# HOWARD UNIVERSITY

OFFICE OF THE SENIOR VICE PRESIDENT  
AND EXECUTIVE DEAN FOR HEALTH SCIENCES  
RADIATION SAFETY OFFICE

**SUBJECT: AMEND LICENSE 08-00386-19  
TO REMOVE RADIOACTIVE WASTE  
STORAGE FACILITY COLLEGE  
STREET 510 – ADDITIONAL INFORMATION**

Diagram of 510 College Street

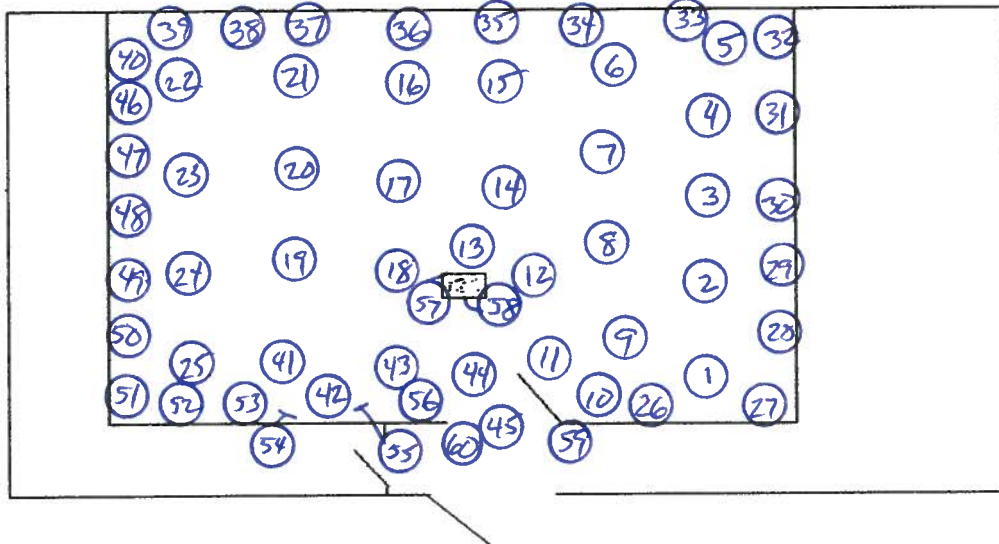
1. Explanations on each item are as follows:
  - a. Provide a description of the facility, including items such as dimensions; type of flooring and wall surfaces; sinks, drains and other permanent fixtures; any remaining equipment associated with radiation safety such as hoods or other containment or ventilation systems.
    - Our records indicate that the communication was facilitated back in 1980, and the authorization to use this facility to store radioactive waste took place thereafter. The dimension of this facility is about 3.2 ft. x 12 ft. (~38 ft<sup>2</sup>), verified by measurements. To my knowledge, three walls are composed of drywall materials and one exterior wall is built with brick. The floor is made of concrete. There are no sinks, drains,

- c. Release surveys must address both total residual contamination, and removable residual contamination. The Alternate Simplified Method requires a minimum of 30 such sample points. Sample points should include floor and wall surfaces. The removable contamination survey performed by your contractor shows only 20 sample points, all on floor or table surfaces. There does not appear to be any static measurements of total residual contamination by the contractor.

- d. The Alternate Simplified Method requires a 100% scan survey of the facility. There does not appear to be a radiation scan of the facility by the contractor.

permanent fixtures or hoods in the facility. The drain is located outside the authorized facility. The room diagram is shown in Figure 1.

- Please see the attached survey results

- Please see the attached survey results
